A meeting of the North Mid Sussex County Local Committee will be held at 7.00 pm on Tuesday, 5 February 2019 at East Grinstead Library, 32-40 West Street, East Grinstead, RH19 4SR

# 7.30 pm 6. **Proposed Traffic Regulation Order - Calluna Drive,** Copthorne (NMS09(18/19)) (Pages 13 - 28)

North Mid Sussex County Local Committee	Ref No: NMS09(18/19)	
5 February 2019	Key Decision: No	
Worth - Copthorne - Calluna Drive Proposed Traffic Regulation Order	Part I	
Report by Director of Highways and Transport and Head of Highway Operation	Electoral Division: WORTH FOREST

Appendix A – plans of existing restrictions and advertised proposals

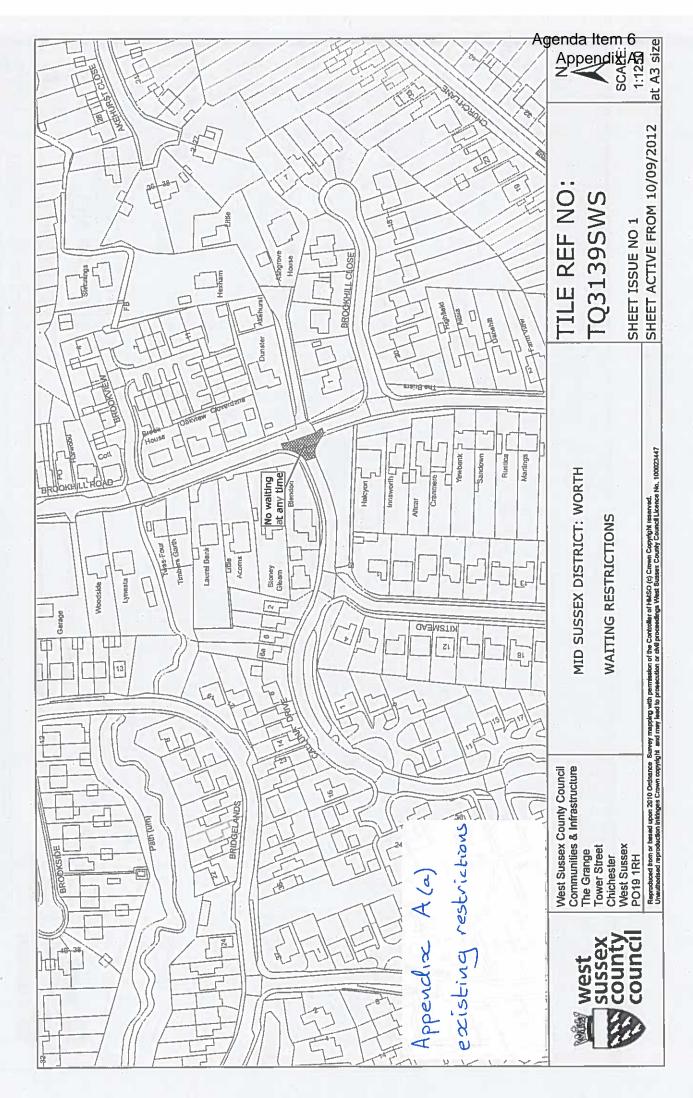
I would be grateful if someone could contact me with reference to the above TRO proposal. I live on the corner of Calluna Drive and Brookhill road which would see my driveway which is the first on the right on Calluna Drive covered by double yellow lines. This poses a big problem to us as a family as we help to care for elderly disabled parents who are unable to walk more than a few steps. Currently the car can pull up in front of the drive and we can assist them to get into the house, however if you put the double yellow lines there this won't be possible. The parking area on your plan located further down the road will not be any help as this is too far for them to walk and also will be full up with the cars parked with Gatwick customers which is a big problem here. Please can someone discuss some options with us, something also to note, our house has single storey living and sleeping arrangements for disabled/elderly people so taking away appropriate parking for ease of care is very concerning.

The proposal is based on incorrect information. In the years I have lived nearly opposite the end of Calluna Drive, I have never seen the parking on both sides of the road. Therefore the risk and danger described does not exist. Having a dog, I walk along the road at least twice a day every day, Parking occurs on the north side regularly, but I have never observed parking on the south side. On average there are between 2-4 cars parked on the stretch under consideration. In addition two larger vehicles are

1 putting lines down will only push airport parking deeper into the estate 2 I also will have nowhere to park my van 3 I have a disabled grandson so how will he visit me

We live at the entrance to Calluna Drive and totally object as we have two work vans that are parked outside our house and they will get broken into if moved elsewhere. We need that parking space airport parking does not interfere with this section. Listen to the people please who live in this part not the people who don't!

It is noticed the proposed lengths of double lines on both sides of Calluna Drive still leave a section for vehicles to park on the north side of Calluna Drive.

Accordingly, I request the TRO be amended in order to prohibit any vehicles waiting at any time on the full lengths of both sides of Calluna Drive, between its junctions with Brookhill Road and Kitsmead.

I support the proposal, however on the drawing it shows a white area. What does this mean, is parking still to be allowed in this area. If so then this negates any safety gain as the problem is caused by vehicles waiting to exit with cars entering. If any parking is allowed this risk will remain. I suggest the order covers the entire stretch of road from Brookhill Road to Kitsmead.

Local residents have reported inconsiderate and obstructive parking at various locations. The statutory consultation process has been followed.

Vehicles parking on Calluna Drive obstruct visibility and affect the free flow of traffic on a bend. The introduction of lengths of double yellow lines here will mean cars are not forced to overtake parked vehicles on a bend and drive on the wrong side of the road where it is unsafe to do so.

Whilst it is accepted that some parking displacement may result, the proposed restrictions aim to reinforce Highway Code Rule 243 on appropriate parking. Parking capacity will still exist in the area and there is reasonable alternative parking in safer locations.

Local residents have reported inconsiderate and obstructive parking at various locations. The statutory consultation process has been followed.

Vehicles parking on Calluna Drive obstruct visibility and affect the free flow of traffic on a bend. The introduction of lengths of double yellow lines here will mean cars are not forced to overtake parked vehicles on a bend and drive on the wrong side of the road where it is unsafe to do so.

Whilst it is accepted that some parking displacement may result, the proposed restrictions aim to reinforce Highway Code Rule 243 on appropriate parking. Parking capacity will still exist in the area and there is reasonable alternative parking in safer locations.

New permit parking schemes for local residents, are no longer available because of reduction of local authority funding and limited budgets for the administration required to run such schemes.

Local residents have reported inconsiderate and obstructive parking at various locations. The statutory consultation process has been followed.

Whilst it is accepted that some parking displacement may result, the proposed restrictions aim to reinforce Highway Code Rule 243 on appropriate parking. Parking capacity will still exist in the area and there is reasonable alternative parking in safer locations.

Some accommodation for resident & visitor parking is necessary. The presence of parking in suitable locations also provides a form of traffic calming and reduces speed in residential areas. The proposal will provide gaps in parking to help avoid conflict for two way traffic.

Local residents have reported inconsiderate and obstructive parking at various locations. The statutory consultation process has been followed.

Whilst it is accepted that some parking displacement may result, the proposed restrictions aim to reinforce Highway Code Rule 243 on appropriate parking. Parking capacity will still exist in the area and there is reasonable alternative parking in safer locations.

Some accommodation for resident & visitor parking is necessary. The presence of parking in suitable locations also provides a form of traffic calming and reduces speed in residential areas. The proposal will provide gaps in parking to help avoid conflict for two way traffic.

Appendix B – summary of objections Appendix C – revised final proposal

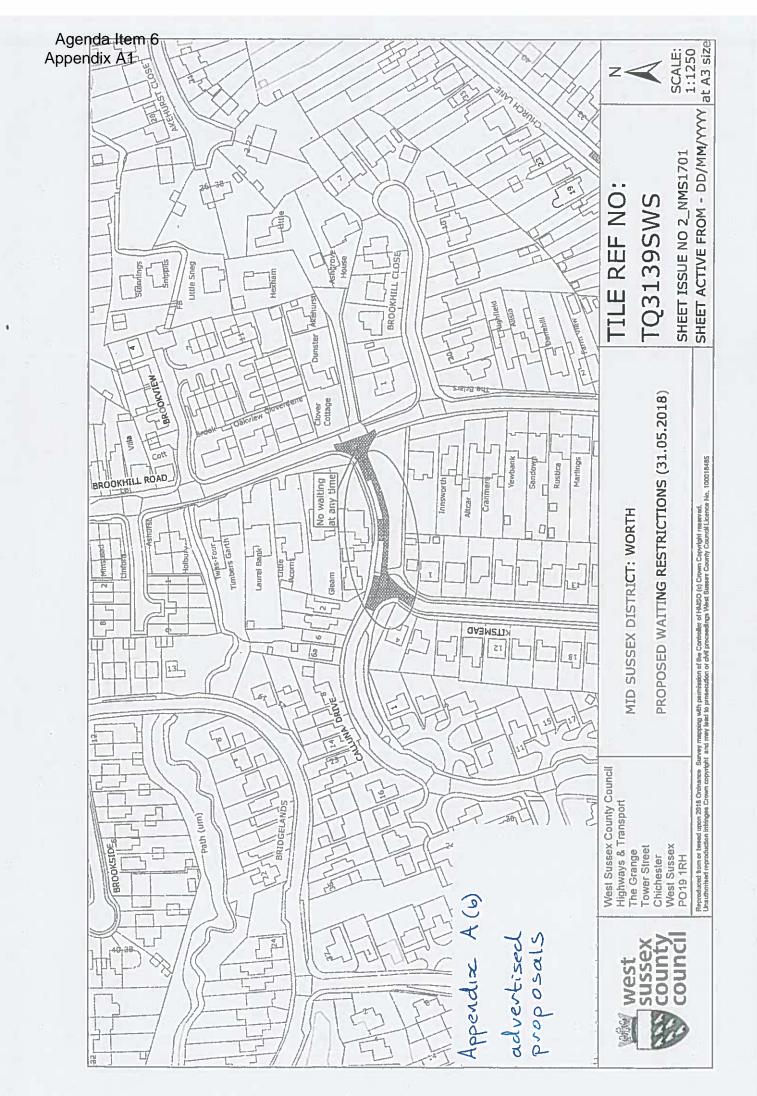
At the North Mid Sussex CLC dated 13 November 2018 members agreed and supported the introduction of a reduced version of the original TRO proposal. Keeping the extended double yellow lines on the junction affecting Calluna Drive off Brookhill Road, further reinforcing rule 243 of The Highway Code.

- 1.6 The Area Highway Manager for the Mid Sussex area met with the Local Member on 31<sup>st</sup> July 2018 to consider the situation. The Local Member made to final decision to remove the majority of the original proposals but decided to retain an extension of parking restriction near the Brookhill Road junction.

That North Mid Sussex CLC, having considered the resulting benefits to the community outweigh the objections raised, authorise the Director of Law and Assurance to make the Order as detailed in the revised scheme at Appendix C.
